Well Name: FOREHAND RANCH 27 STATE COM	Well Location: T23S / R27E / SEC 27 / NWNE / 32.2825666 / -104.175658	County or Parish/State: EDDY / NM
Well Number: 1H	Type of Well: OIL WELL	Allottee or Tribe Name:
Lease Number: NMNM112915	Unit or CA Name: FOREHAND RANCH 27 STATE COM1H	Unit or CA Number: NMNM128667
US Well Number: 3001539844	Operator: 3R OPERATING LLC

Notice of Intent

Type of Action: Plug and Abandonment

McVay Services **Forehand Ranch 27 State Com #1 H - Proposed** 30-015-39844

McVay Services
Forehand Ranch 27 State Com #1 H - Proposed
30-015-39844

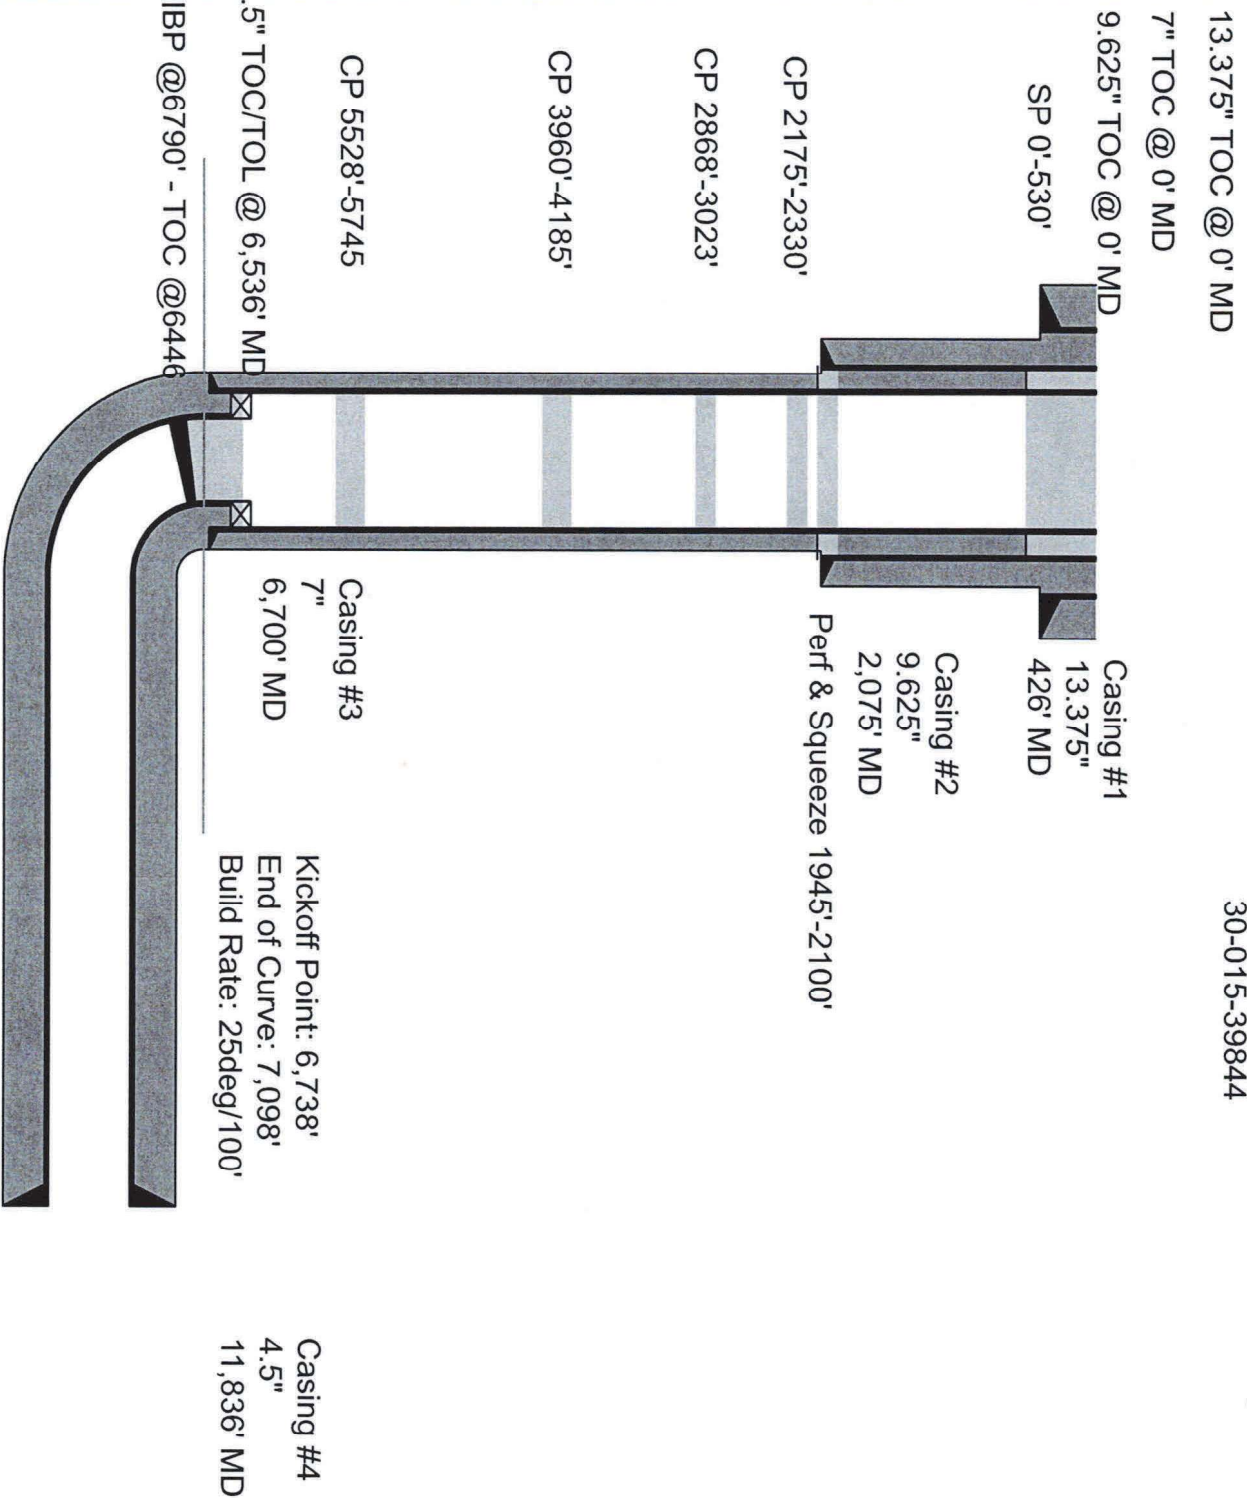
1. MIRU NU BOP
2. RU Wireline, RIH GR/JB then RIH CIBP to 6790'
3. Run CBL to surface
4. SPOT 25 SX on top of cast iron TOC@6446' (Class H) (WOC 4hrs)
5. SPOT 35 SX from 5745'-5528' (WOC 4hrs)
6. SPOT 35 SX from 4185'-3960' Potentially covering casing leak, (WOC 4hrs)
7. SPOT 25 SX 3023'-2868' (WOC 4hrs)
8. SPOT 25 SX 2330'-2175' (WOC 4hrs)
9. Perf and Squeeze 9.625 Casing Shoe SPOT 25 SX SPOT 2100'-1945' (WOC 4 Hrs)
10. SPOT 25 SX 1350'-1195' (WOC 4Hrs)
11. Perf and Squeeze 13.375 Shoe and Circulate All Strings To Surface with Cement (100 SX)

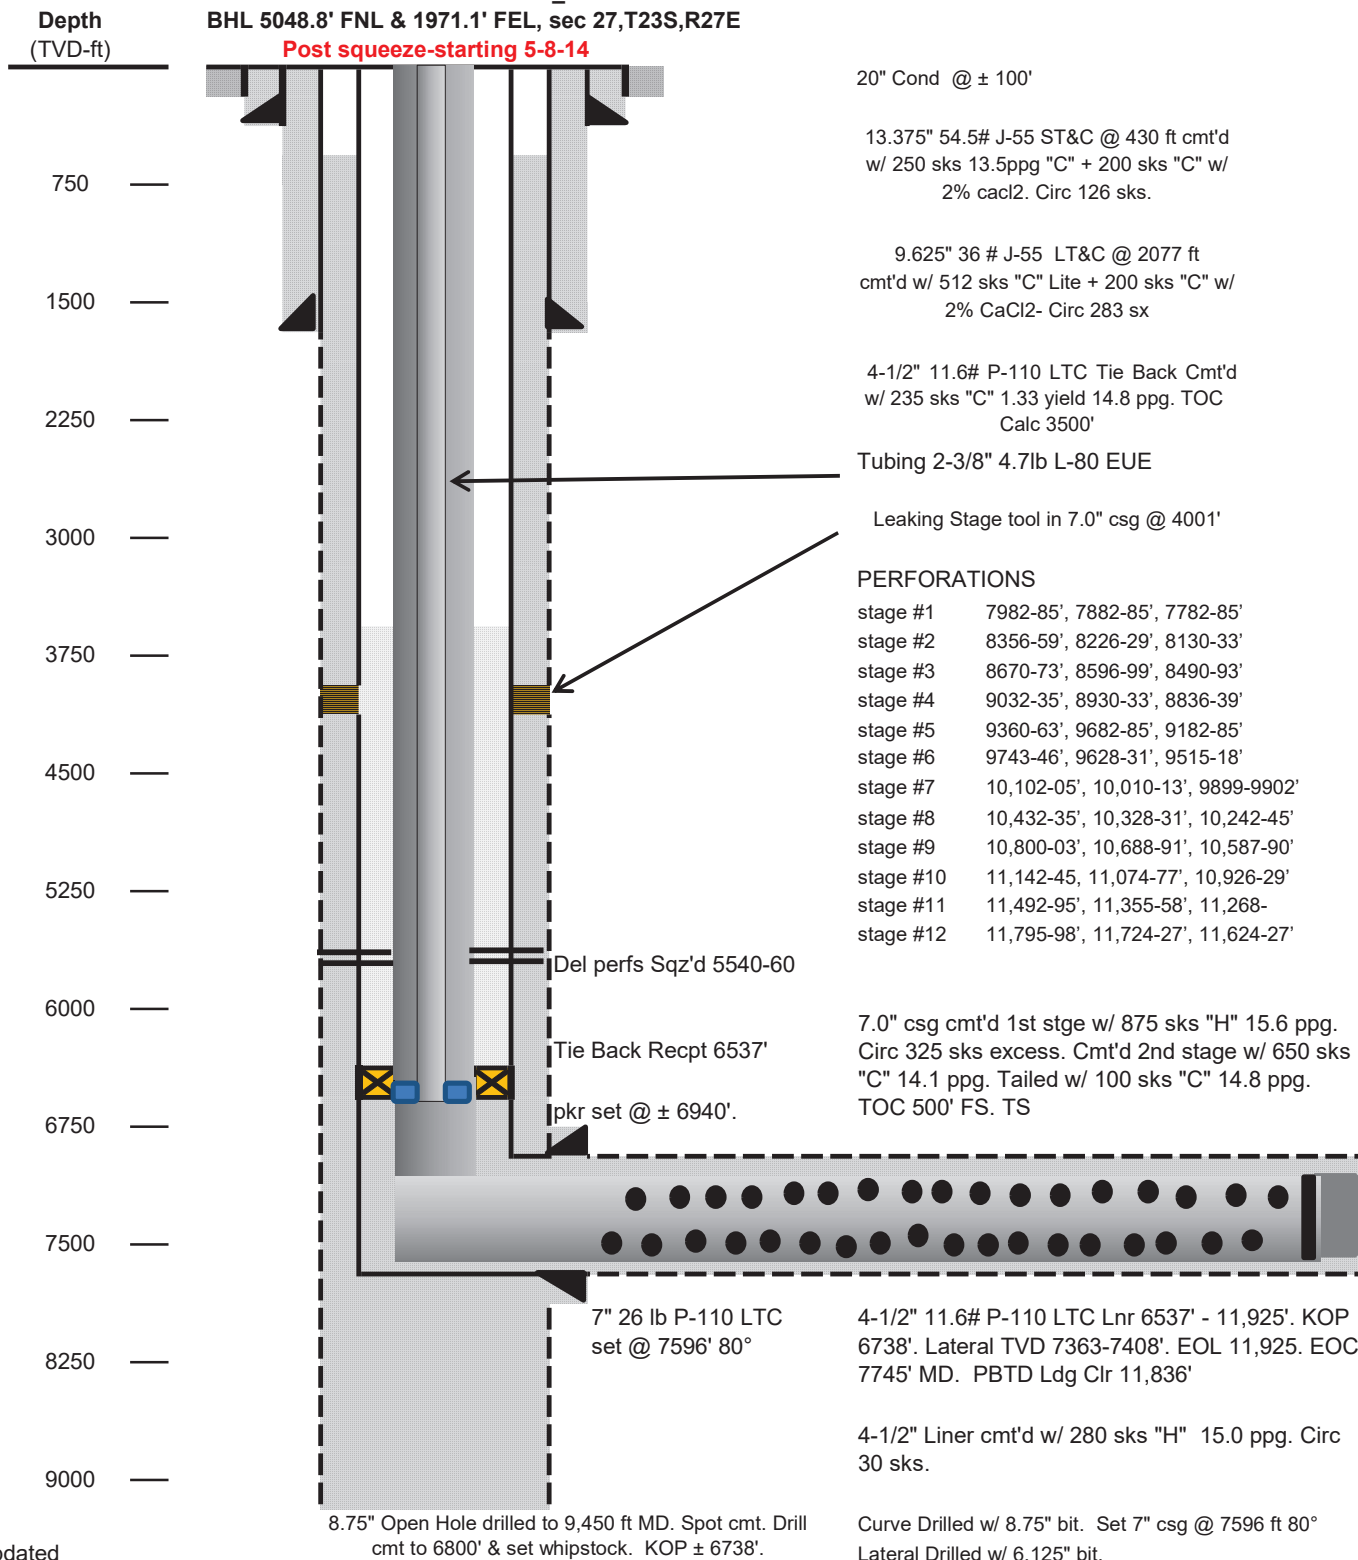
REVISED

SP 0'-560'

Perf & Squeeze 1930'-2310'

~~CP 2175'-2330'~~

CP 2868'-3023'

CP 3910'-4185'

CP 5745'-5454'

*Run CBL from CIBP to surface.

Submit results to BLM.

1. MIRU NU BOP
2. RU Wireline, RIH GR/JB then RIH CIBP to 6790'
3. Run CBL to surface
4. SPOT 25 SX on top of cast iron TOC@6446' (Class H) (WOC 4hrs)
5. SPOT 35 SX from ~~5745'-5528'~~ (WOC 4hrs) 5745' to 5454'
6. SPOT 35 SX from ~~4185'-3960'~~ Potentially covering casing leak, (WOC 4hrs) 4185' to 3910'
7. SPOT 25 SX 3023'-2868' (WOC 4hrs)
8. ~~SPOT 25 SX 2330'-2175' (WOC 4hrs)~~ Perf and Squeeze from 2310' to 1930', (In 21 sxs/Out 31 sxs) WOC and Tag.
9. ~~Perf and Squeeze 9.625 Casing Shoe SPOT 25 SX SPOT 2100'-1945' (WOC 4 Hrs)~~
10. SPOT 25 SX 1350'-1195' (WOC 4Hrs)
11. Perf and Squeeze ~~13.375 Shoe~~ and Circulate All Strings To Surface with Cement (100 SX) 560' to surface.
